Central Parc at North Port Pattern Plan Amendment

Petition No. PMCPA-24-00000114

(Formerly DMA-24-114), via Ordinance No. 2025-28

Presented by: The Planning & Zoning Division

Central Parc Proposed Buffers

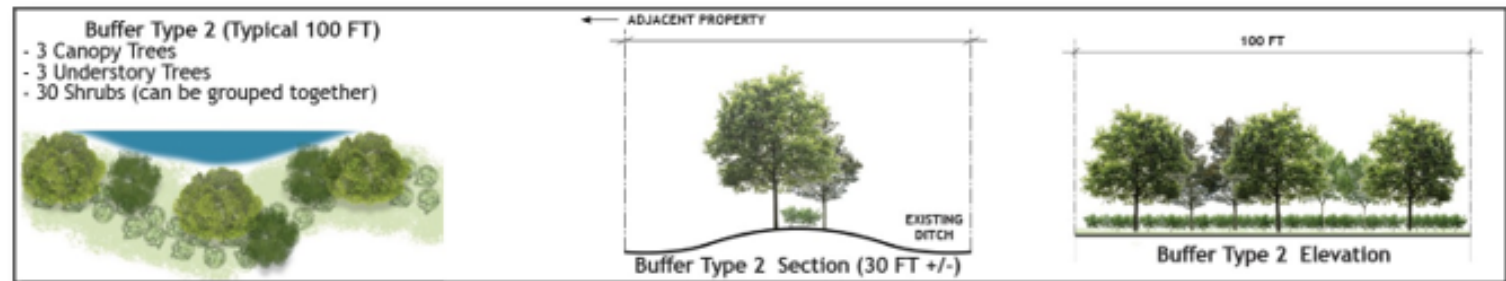
Proposed Buffer Type 2 - is a 30' wide open space area having 3 canopy trees, 3 understory trees, 30 shrubs every 100' on a small berm. The shrubs can be grouped together. This buffer type is located at the property line between the lakes and the adjacent residential properties. The berm has been removed with the proposed amendment, and the elevation relates to an existing ditch.

Staff also believes that the intent to provide views of the lake can be met by simply updating the Type B buffers to exclude the required berm and shrubs. Three (3) canopy trees and three (3) understory trees every 100 linear feet will not create visual barriers, and in fact, may create more scenic views of the lake, provided that the planting style is staggered and randomized to provide a less curated appearance.

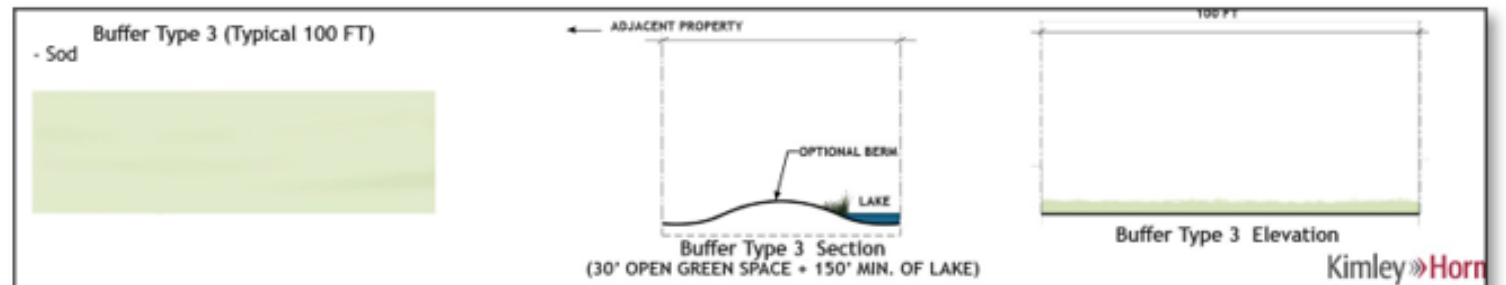
Proposed Buffer Type 3 - is a 30-foot wide open space featuring sod and an optional berm. The sod will be placed in locations where the lake adjoins residential and mixed-use areas 1 and 2.

The request to eliminate plantings adjacent to Lake 5 is not supported. The 2010 ULDC requires a 10' Type B buffer where single-family/two-family residential is adjacent to multifamily uses. The approved Pattern Plan includes an enhanced buffer for added protection between different densities and heights. Retaining the enhanced buffer is essential for compatibility between current and future uses of the two districts.

The request to eliminate planting adjacent to Lake 9 is not supported. The 2010 ULDC requires a 10' Type B buffer in this location where single-family/two-family residential is proposed adjacent to existing multifamily uses. It is important to recognize that the adopted Pattern Plan has an enhanced buffer approved in this location providing additional protection between uses of varying density and heights. To ensure compatibility between current and future uses of the two districts, the enhanced buffer should be retained.

Staff does not support this waiver request. The buffer in this location provides screening between the entrance right-of-way from Appomattox Drive to the development, and the front and rear of existing single-family residential lots. Removing screening commitments in this location would create noise, light nuisance for the adjacent residences. Staff recommends retaining an enhanced buffer in this location.
